From: Danny Moore
Sent: 7/02/2024 6:28:52 PM
To: Council Northernbeaches Mailbox
Subject: Submission Re DA2023/1858
Attachments: Moore submission.docx;

Submission - DA2023/1858

We are writing in relation to the development application for 14 Birkley Rd Manly.

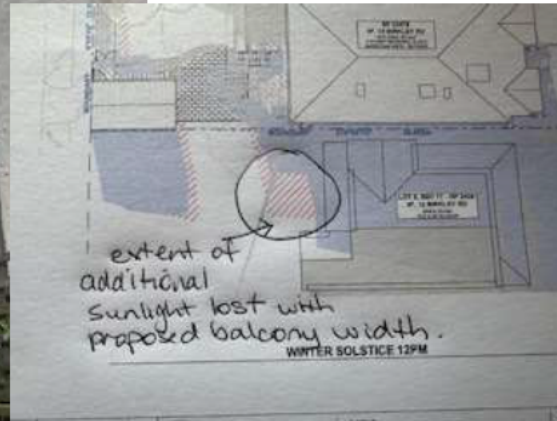
This image shows the current balcony which sits off the boundary by around 2-2.5metres.
